**46-22-01 - Front of Vehicle Rattle/Knocking Noises when Driving on Poor Roads**

Release date: 4/24/2023

**Figure 1: Front left brake system**

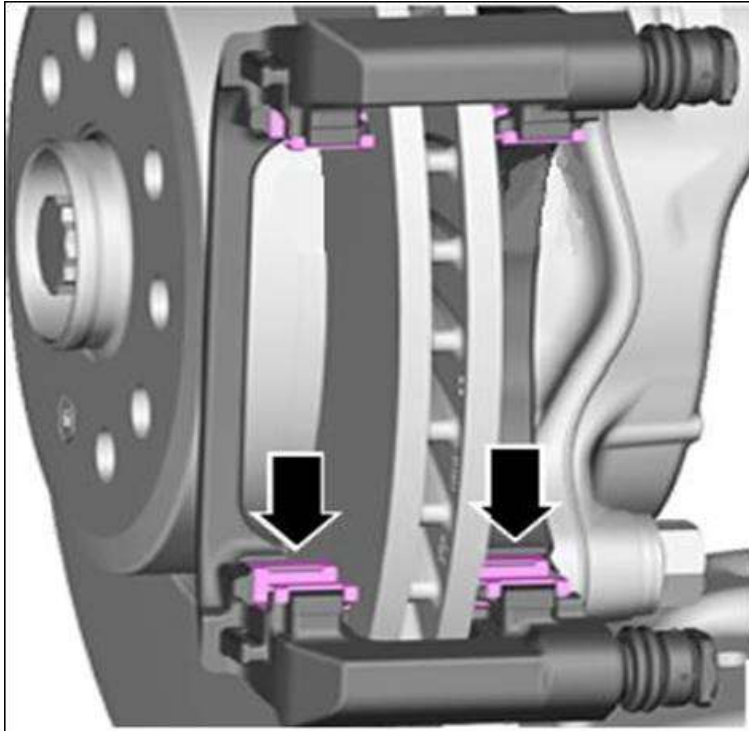
- Remove the front brake pads and lower retaining plates according to the repair manual (Figure 1, arrows).

**Figure 2: Retaining plates for the front brake pads.**

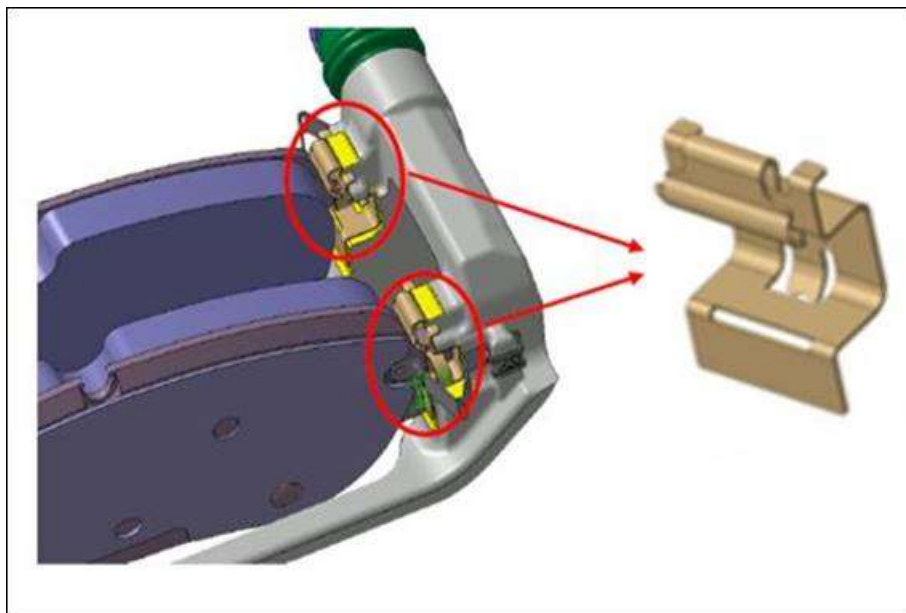
- Install new lower retaining plates for brake pads (part number 1EA 615 231 B, see Figure 2) together with the original brake pads according to the repair manual.
